SUBJECT: NuScale Power, LLC Supplemental Response to NRC Request for Additional Information No. 136 (eRAI No. 8933) on the NuScale Design Certification Application

NuScale Supplemental Response to NRC Request for Additional Information eRAI No. 8933

NRC Question No.: 03.07.02-16

Figure 3.7.2-172: Floor In-Structure Response Spectra at El. 50 ft, (Z=420 in.) Comparing Full and Empty Dry Dock Conditions

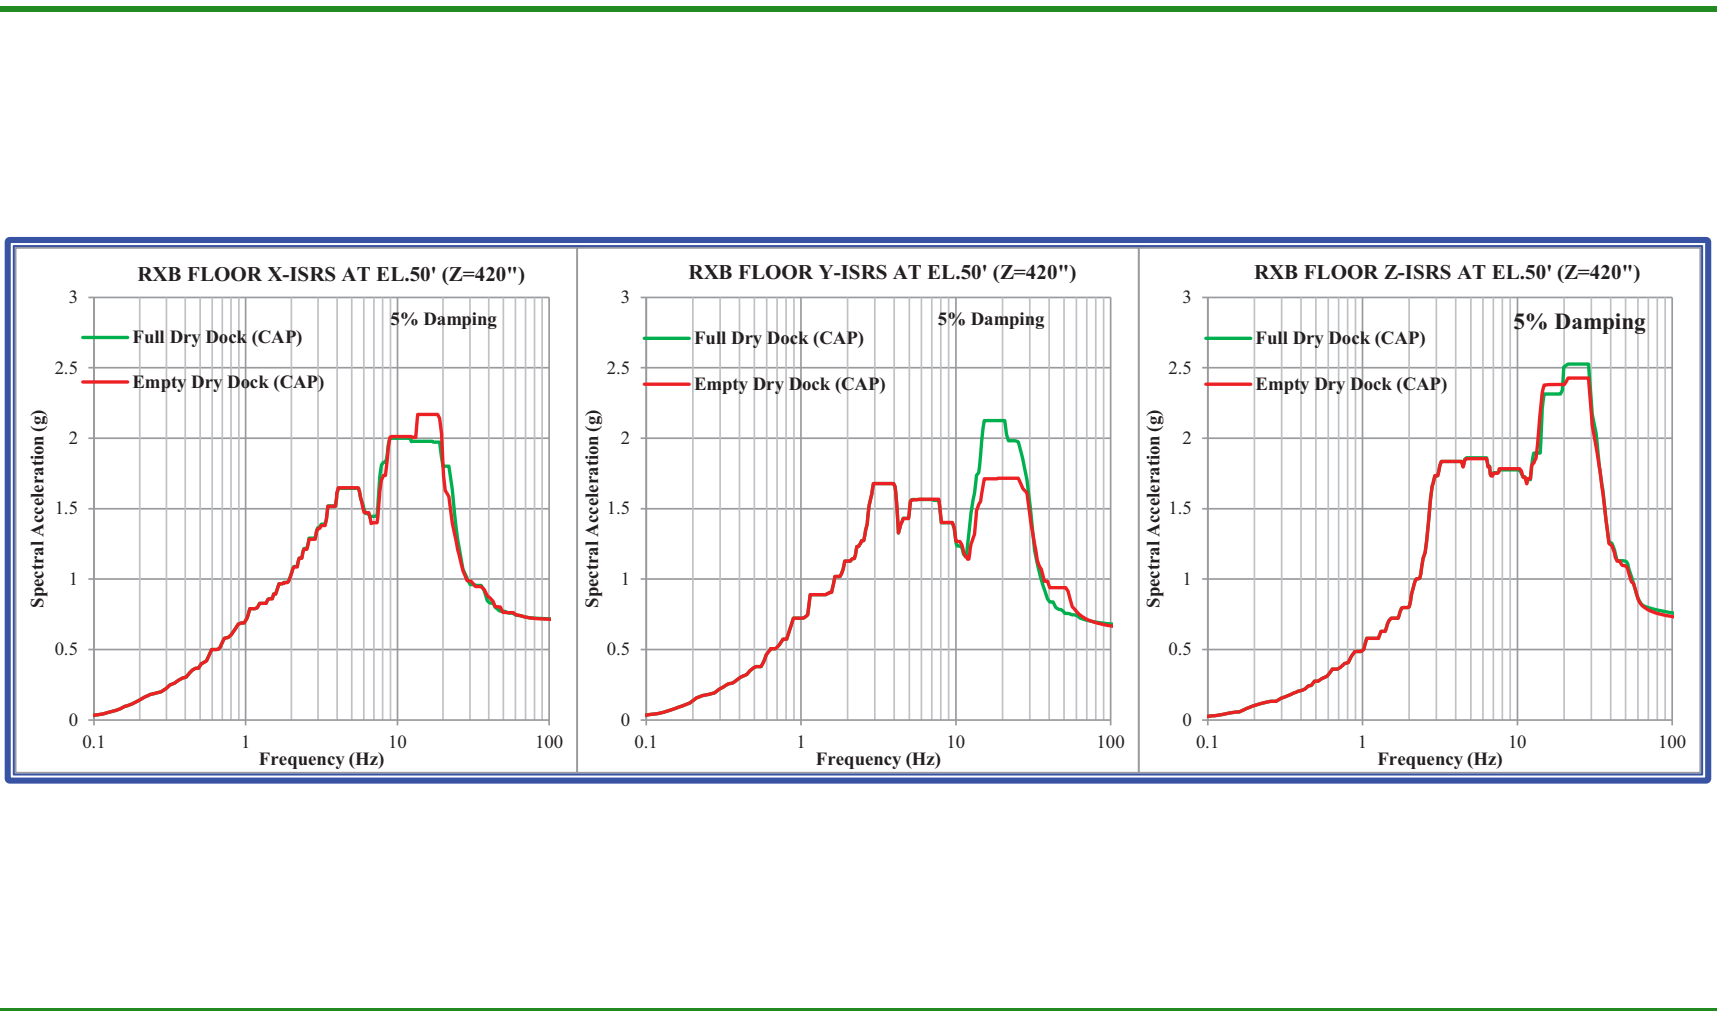
3. The sensitivity study was performed for one concrete condition (cracked) with Soil Type 7 and one CSDRS-compatible Capitola input. The ISRS from the sensitivity study for the empty dry dock model were then compared against the enveloped RXB ISRS (e.g., FSAR Figure 3.7.2-107). However, this comparison may not be appropriate for the NPM system because the seismic input for the NPM analysis is not based on the above enveloped RXB ISRS. Therefore

the applicant is requested to provide comparisons that is consistent with the NPM support input used for the detailed NPM analysis.

The seismic inputs used for the NPM are time histories, and do not lend themselves to direct comparison from one case to another. Instead, direct comparisons between the empty and full dry dock condition are shown in the response to NRC Statement 2, based on consistent input parameters for the RXB model in lieu of comparisons on an NPM analysis basis. In addition, direct comparisons of floor ISRS at El. 50', El. 75', El. 100' and ISRS at a selected Reactor Building crane wheel node, 29545, due to the Capitola seismic input are provided below. The X (East-West), Y (North-South), and Z (vertical) direction ISRS for the floors and at the crane wheel node are shown in FSAR Figure 3.7.2-156 through Figure 3.7.2-159 in the attached FSAR Change Package. The comparison shows that the ISRS are not adversely affected by an empty dry dock.

Comparisons between floor ISRS and ISRS at the Reactor Building crane wheels were also made. These plots can be found in Figure 3.7.2-172 through Figure 3.7.2-175.
